J. H. FLETCHER & CO. Box 2187 – Huntington, WV 25722-2187 – 304/525-7811 – FAX 304/525-4025

INFORMATION BULLETIN NO. 110A

TO: OWNERS OF J.H. FLETCHER & CO. MODEL DR AND CDR SINGLE MAST FEED ROOF DRILL ONLY

SUBJECT: MAST FEED CYLINDER GUARD * FREE OF CHARGE*****

TITAN MAST GUARD

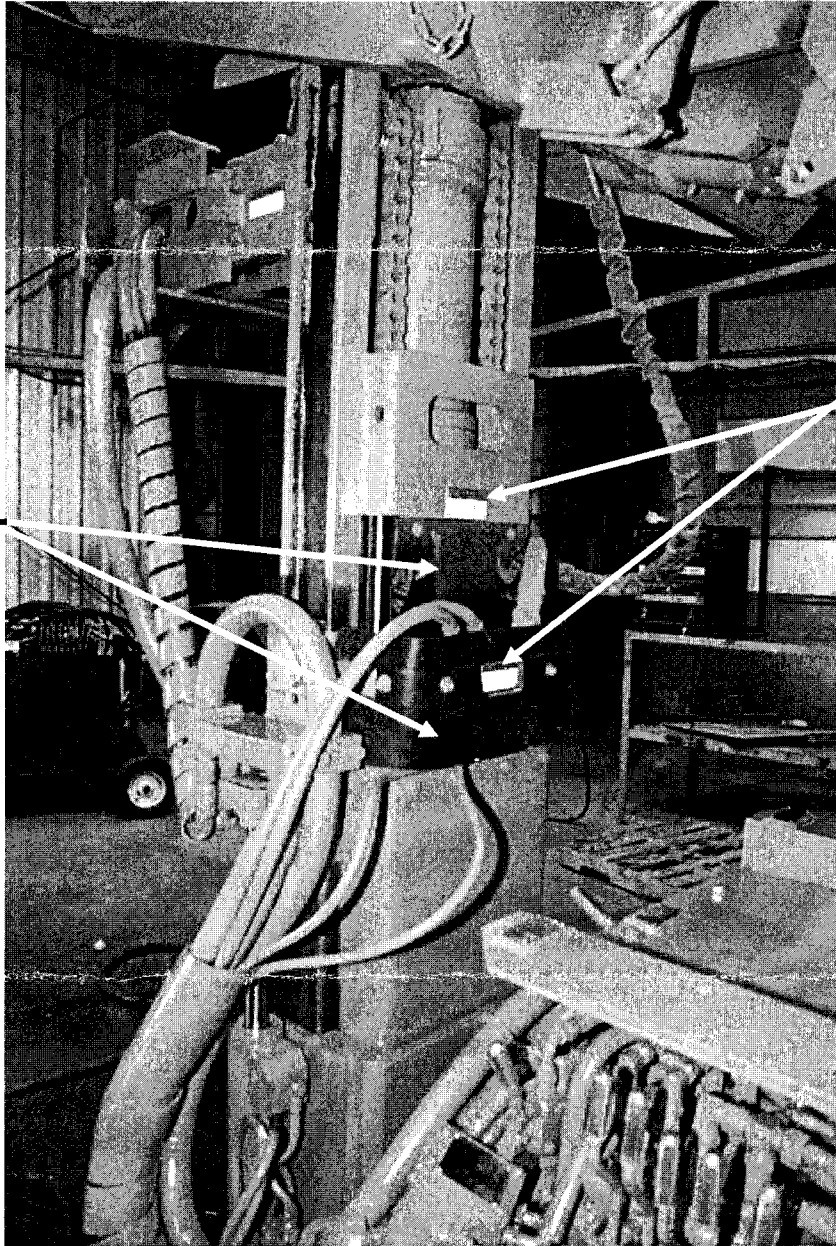
Even though there is no operational need for a roof bolt operator to place a hand, or any body part, between the inner and outer mast during operation, Fletcher is aware that some operators have done so. Fletcher has developed a guard to prevent access to this pinch point area, thereby eliminating the risk of serious injury to the operator. **THIS POTENTIAL SERIOUS INJURY IS PREVENTABLE IF THE MAST FEED GUARD IS INSTALLED.**

The pinch point between the inner and outer mast is created when the drill mast moves up or down during drilling and bolting process. This RAPID mandatory movement of the machine during the bolting cycle can occur hundreds of times during a normal work day.

In order to discourage and prevent an operator from placing a hand or other body part in this pinch point area, Fletcher previously offered this mast feed cylinder guard in Information Bulletin 110 to owners of specific Fletcher DR and CDR roof drills (see photo in Attachment 1).

The mast guard kit (PN: 415666) is offered **FREE OF CHARGE** to any customer who has one of these specified machines. Since the first publication of this important safety notice, Fletcher has had limited customer participation in this retrofit.

GUARD
KIT
PART NO.
415666
